**CITY OF SAINT PAUL
HERITAGE PRESERVATION COMMISSION STAFF REPORT**

FILE NAME: 480 Grand Hill – Frederick Weyerhauser House

STAFF INVESTIGATION AND REPORT: John Beaty, Christine Boulware

DATE: February 19, 2015

Conservatory - View 1

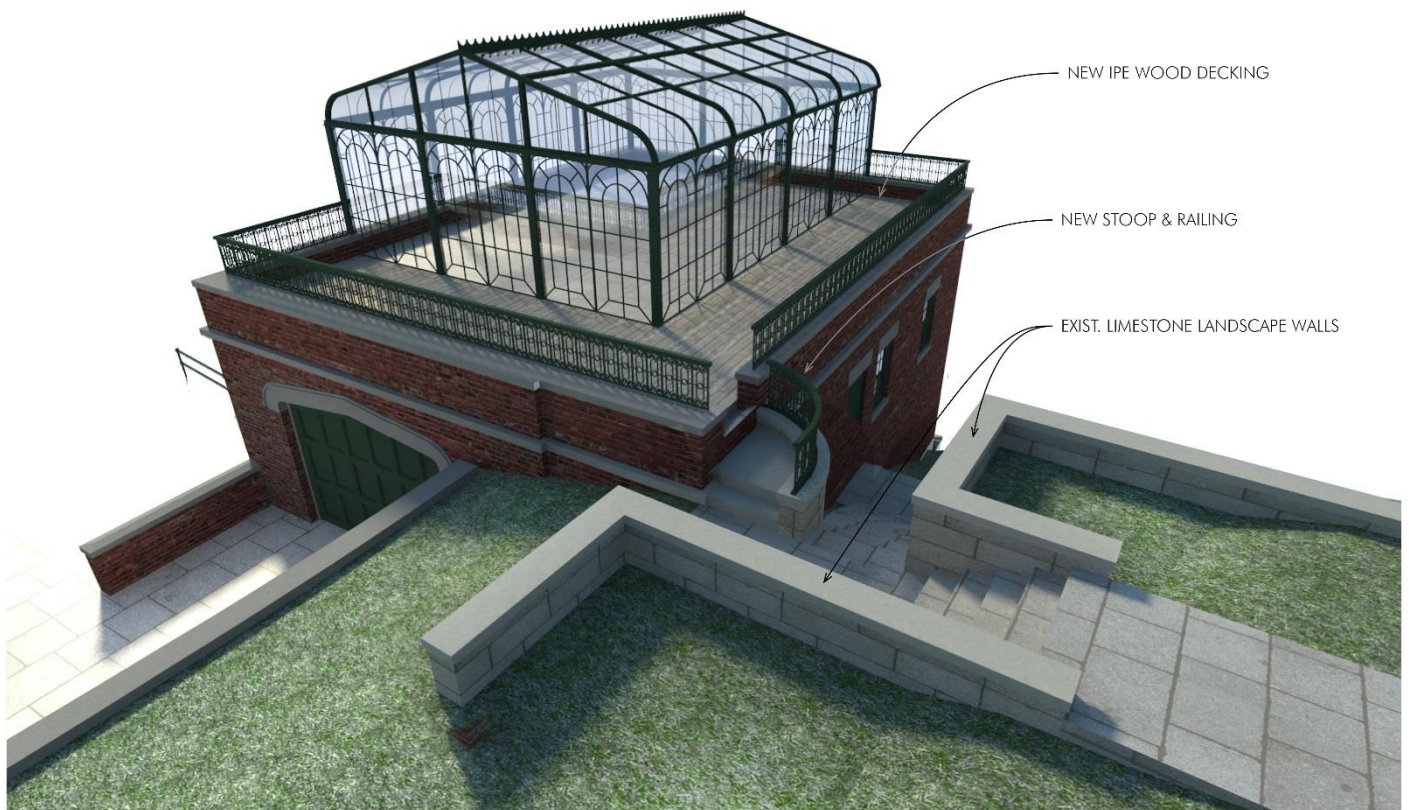
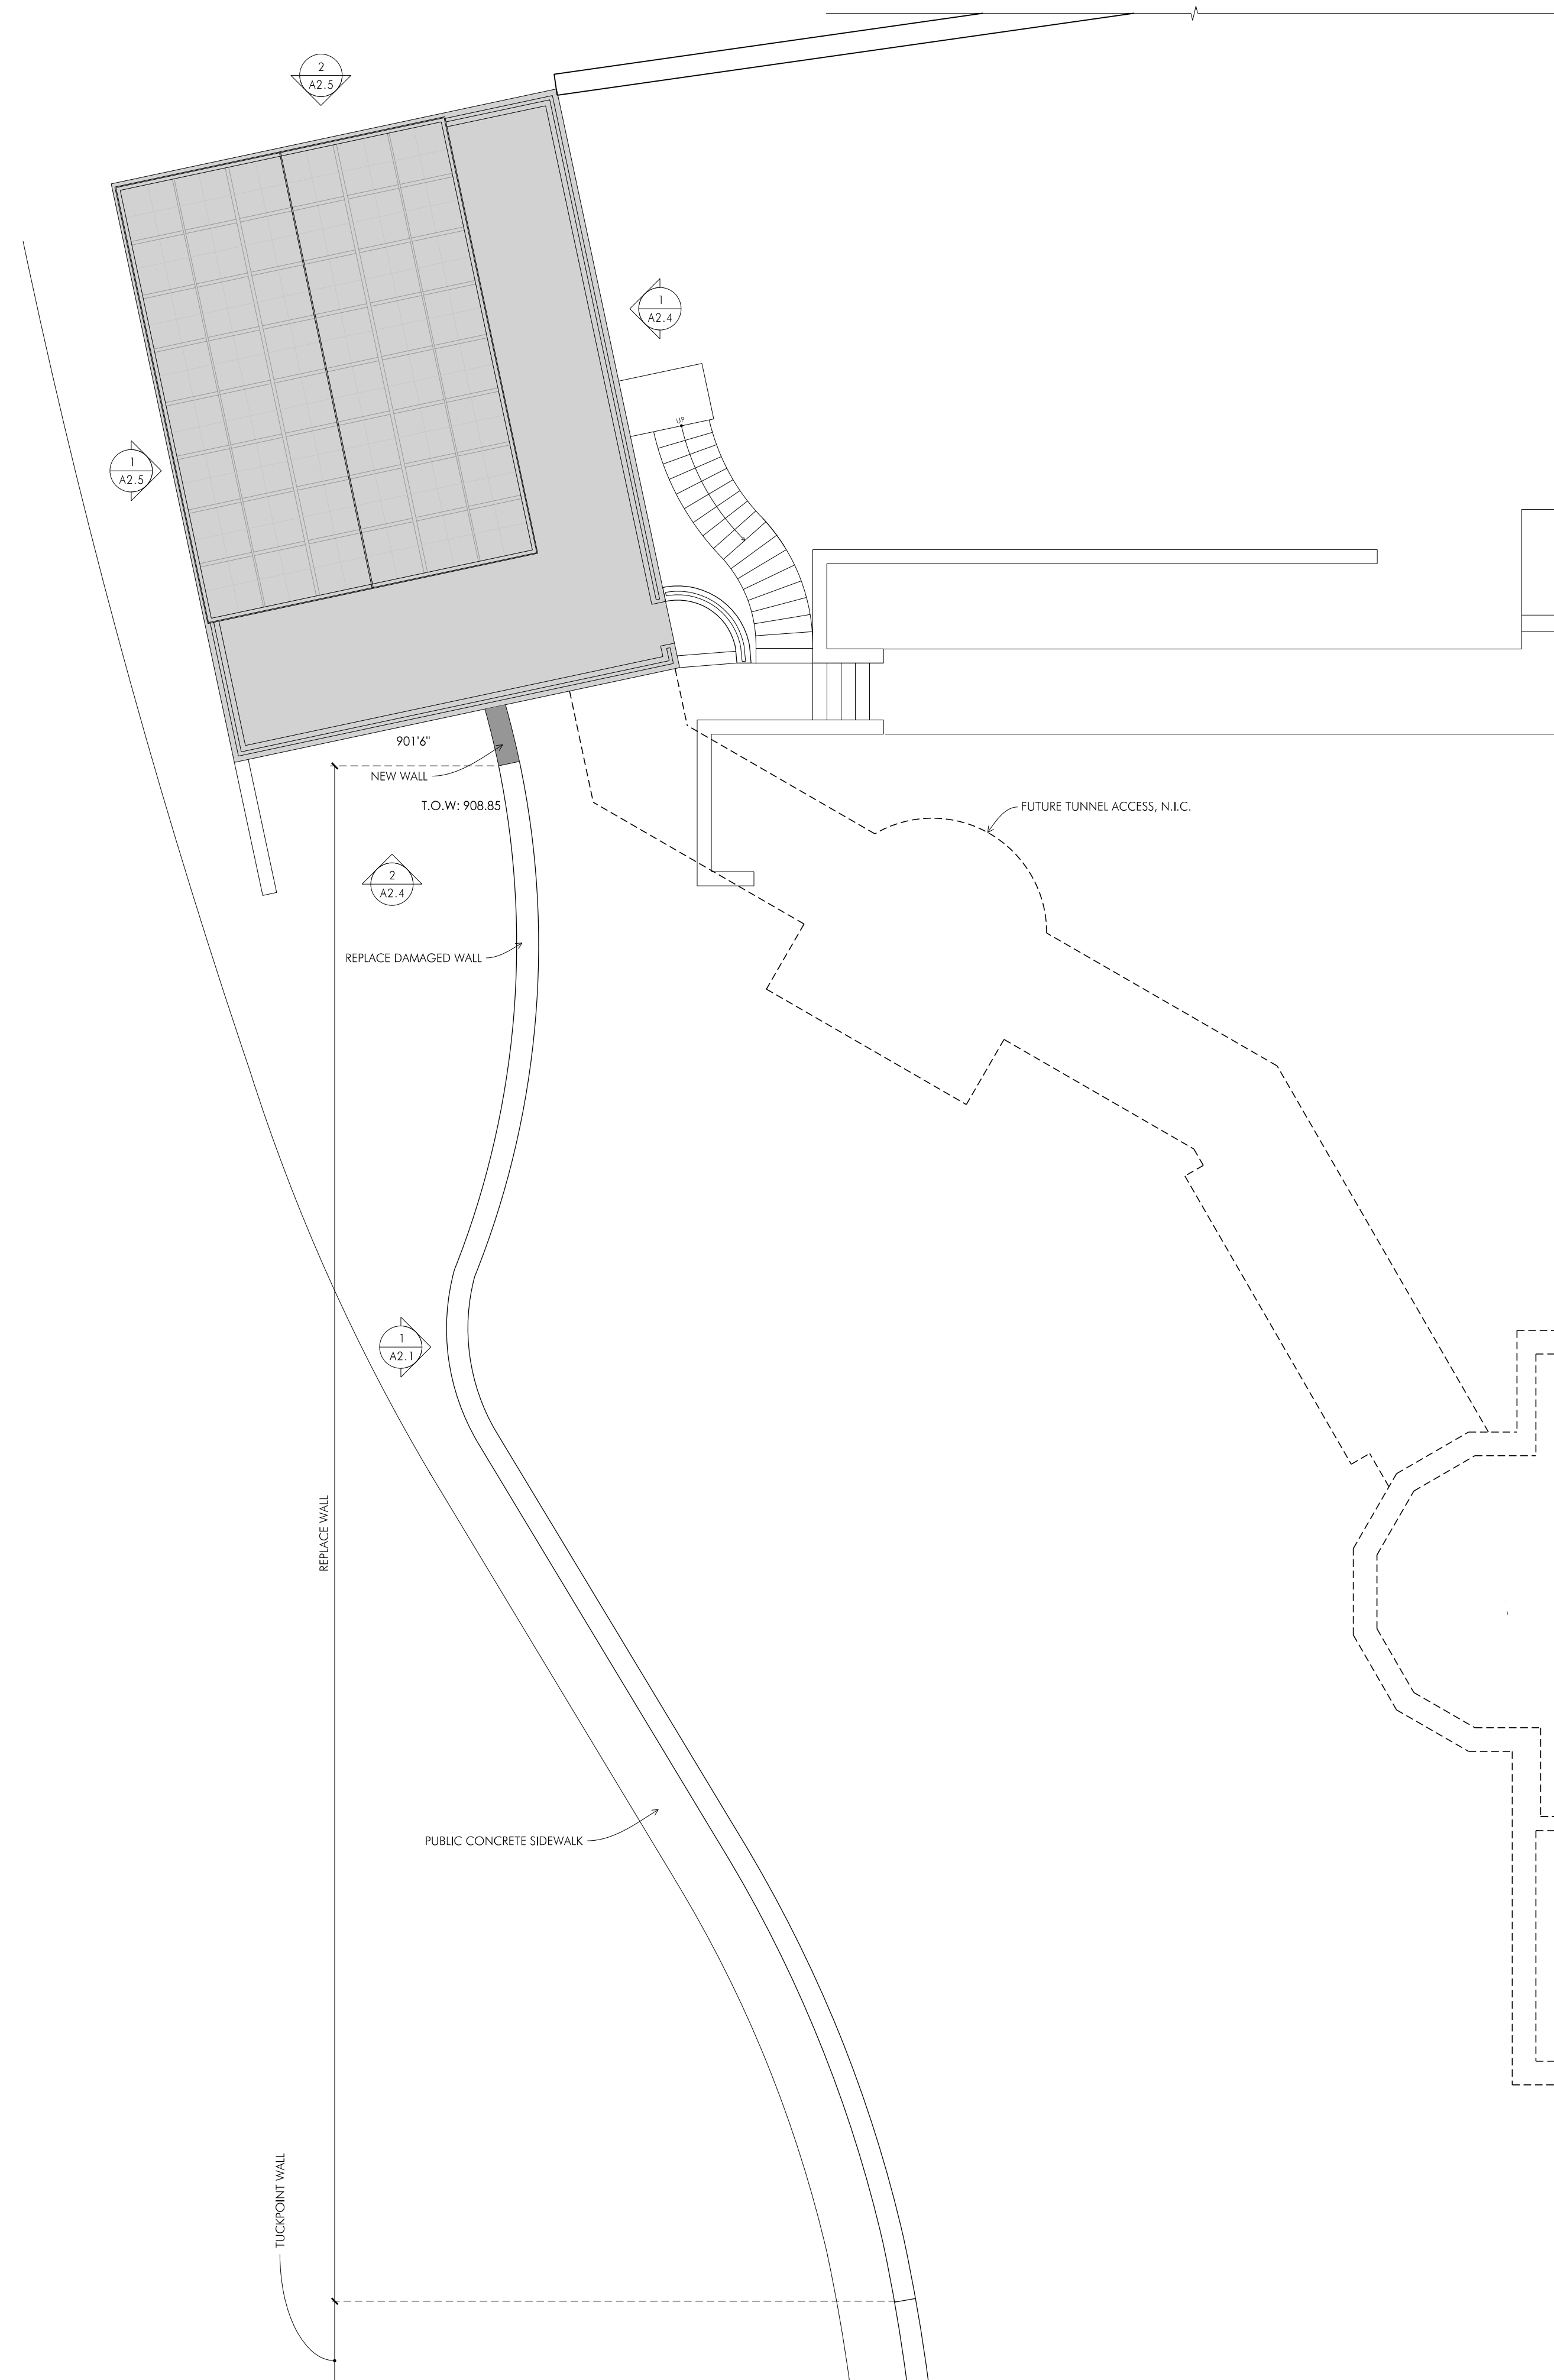
- d. **General Principle §74.64(a)(9)** The proposed new deck is on the flat roof of the garage, behind the parapet walls. The proposed new conservatory is sited on the southeast corner of the roof; back from the north (front) and west elevations. It is also slightly shorter than the walls of the garage visible from the north. These details mostly comply with because the work will *not destroy historic materials that characterize the property*, and it will *be differentiated from the old and ... compatible with the massing, size, scale, and architectural features to protect the historic integrity of the property and its environment*. The one-story scale generally complies because it *maintain[s] the district's scale and quality of design*, and is *compatible with the size, scale, massing, height, ... setback, color, material, building elements, site design, and character of surrounding structures and the area*.

- e. **Material and Details §74.65(d)(2) and (4) and (e)(2)(c)** The proposed conservatory is comprised of metal and glass with a roof shape recalling the Tudor arch detail evident on both the garage and house. This complies with the guidelines by having materials and details that *relate to the materials and details of existing nearby buildings*. Schematics show the metal with a dark finish, which complies with the guidelines by not looking *like raw metal appliances*. However, the cresting detail along the ridge of the proposed conservatory is excessively detailed when compared to the tile ridge on the main house, and does not relate to it.

- g. **Material and Details §74.65(c) and (e)(2)** The divisions of the conservatory walls are tall and narrow, which complies with this guideline. However, the use of arch-headed details does not relate to rectangular openings of the house and garage. The rhythm of the proposed divisions, with twinned "windows" separated by vertical structure, does not quite relate to the ribbon windows on the house, which have single windows separated by mullions.

5. The window division and cresting details of the proposed conservatory should be simplified to better reflect the details and proportions on the main house.

1 Proposed East Garage & Wall Elevation
SCALE: 1/8" = 1'-0"

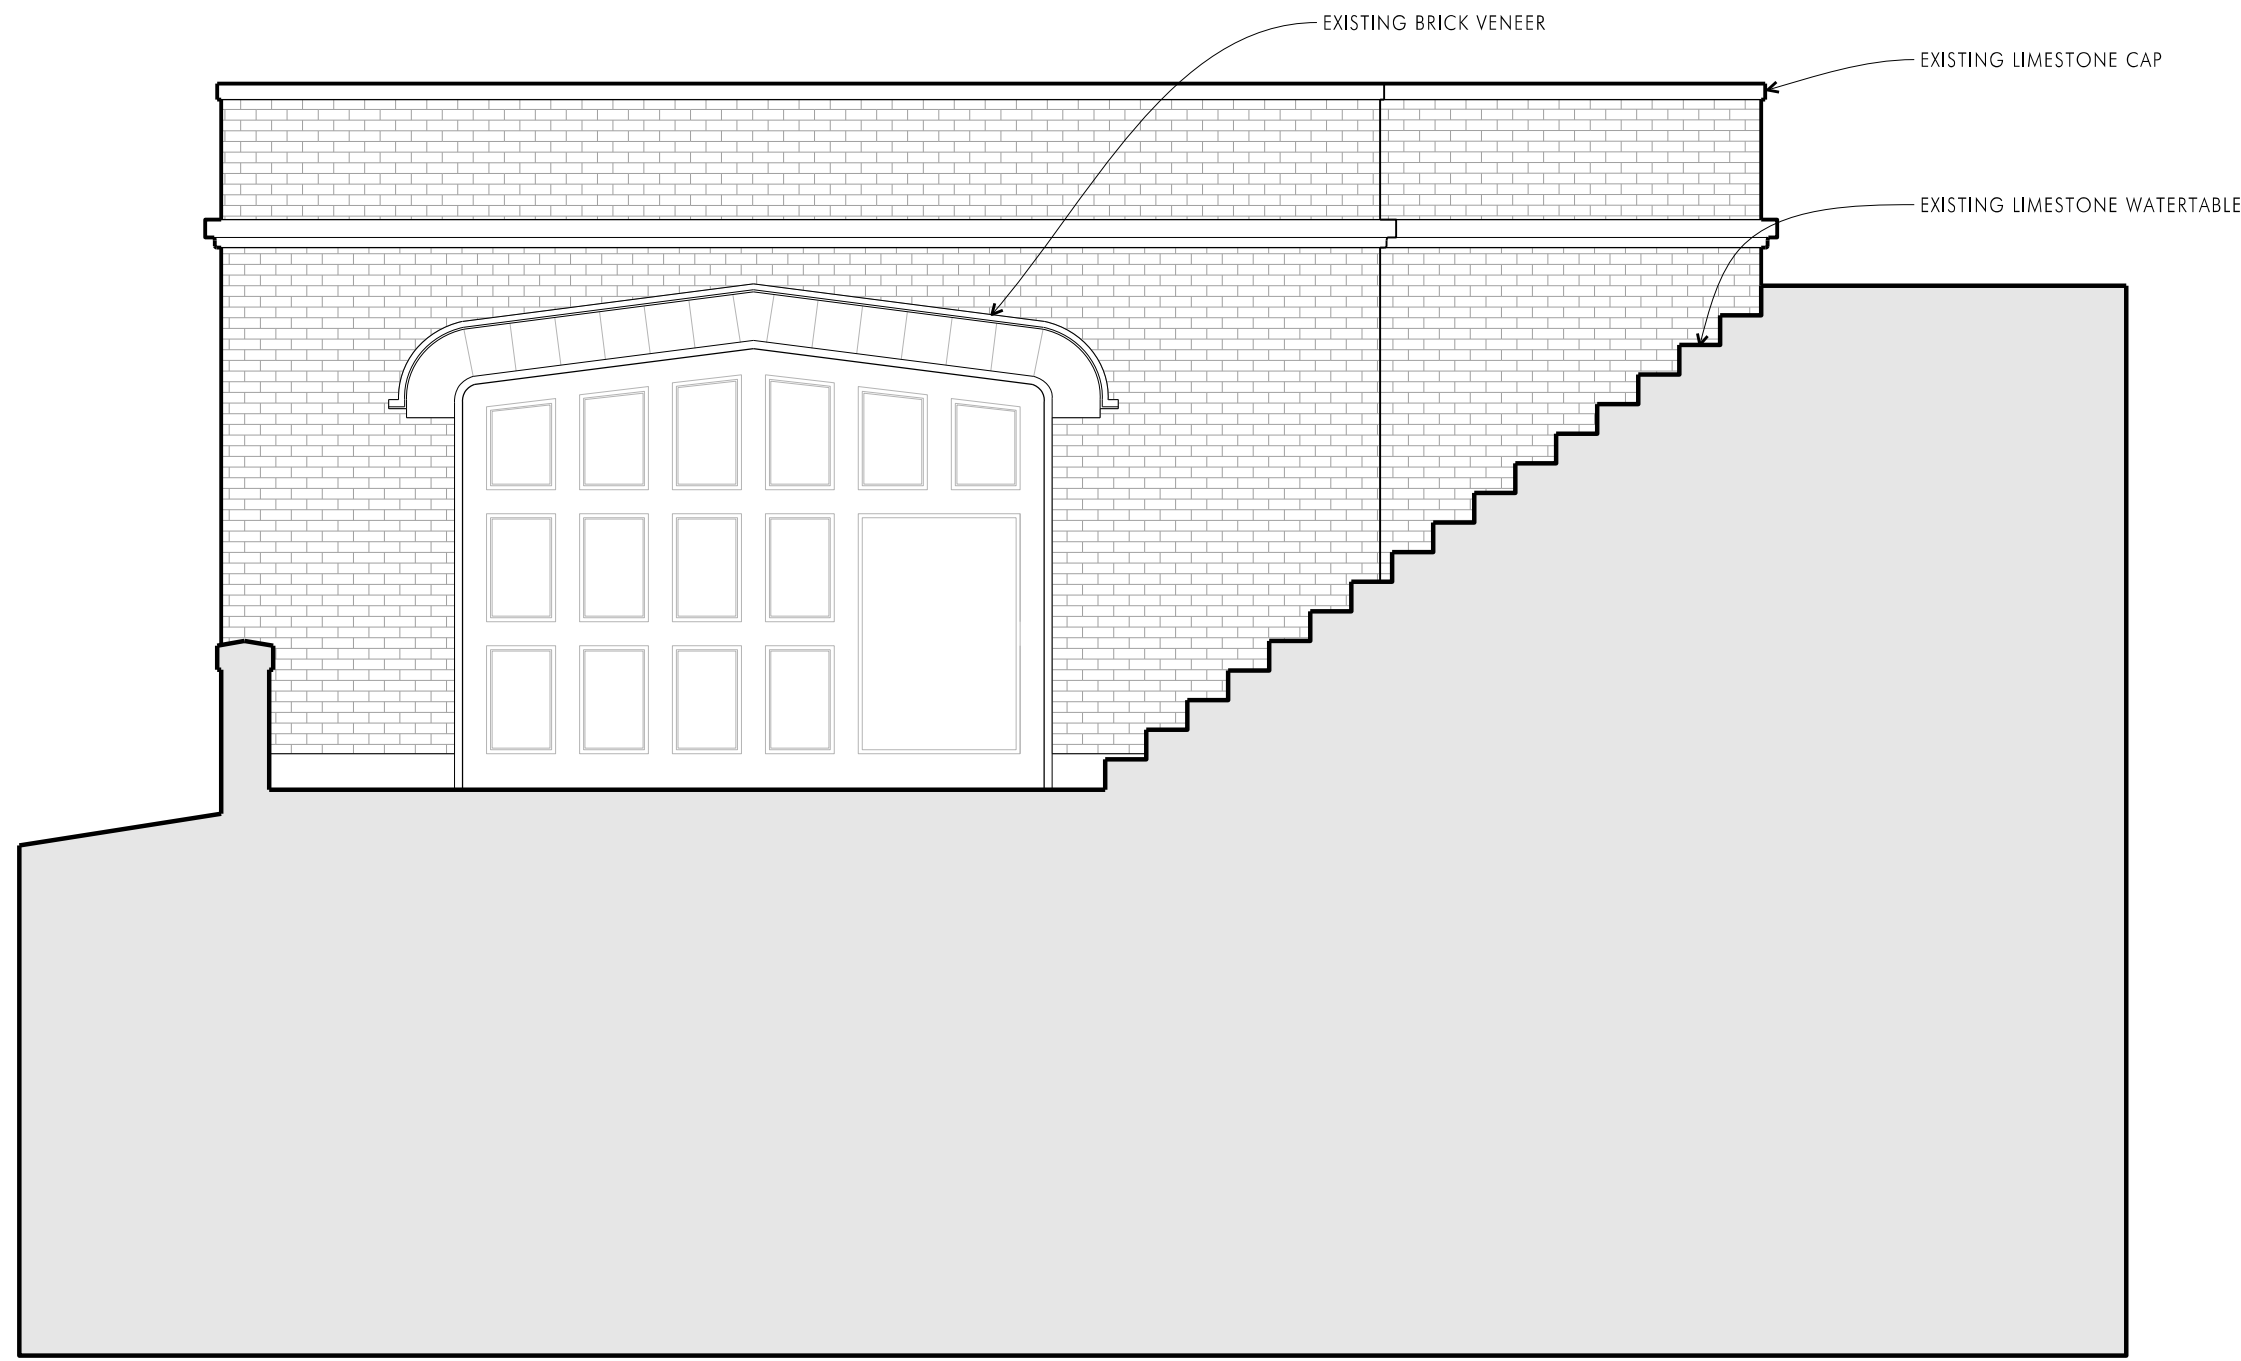
3. The findings for the reconstruction and repair of the retaining wall are as follows:
 - a. **General Principle §74.64(a)(2) and (f)(2)** The proposal to remove the steps adjacent to the garage will result in the removal of a hardscape element of the property, but not one that characterizes the property. The new section of the wall should be distinguished and compatible with historic sections, and its construction should avoid *removal or alteration of any historic material or distinctive architectural features*.

- b. **General Principle §74.64(a)(6)** The disassembly and rebuilding of the retaining wall would match the old in design, color, texture, and other visual qualities and, where possible, materials. Because the rebuilding will replicate the existing design and size, and will reuse as many historic bricks and possible, this proposal generally complies with this guideline.

- c. **General Principle §74.64(a)(10)** the new section of wall should not visually tie into the garage so that *if removed in the future, the essential form and integrity of the historic property and its environment would be unimpaired*.

- d. **Masonry and Foundations §74.64(b)(2)** The new work should closely match the existing joint size and bonding pattern (Flemish bond) in order to comply with the guidelines that state *"Original mortar joint size and profile should be retained and replacement mortar should match the original mortar in color and texture"*. The new mortar will be same mortar used for the repointing of the main house, which was approved by HPC staff on October 1, 2014 (File #14-334426).

- e. **Landscaping §74.65(f)(2)** Restoring the wall to its original height maintains the visually semi-open character of the site along Lawton Street.

1. The new section of the wall, which covers the space where the stairs will be removed, shall be built entirely with new bricks and set back a minimum of one inch from the face of the wall. It shall have a limestone cap which matches the existing historic cap as closely as possible.

2. The new section of the wall shall not be visually attached to the garage. For reversibility, any attachments between the wall and the garage shall be made below the level of the existing stairs.

3. The new section of the retaining wall shall not remove or alter any of the belt course or voissiors on the garage.
4. The reconstructed portion of the retaining wall shall match the existing wall in height, bonding pattern, joint size and joint profile.
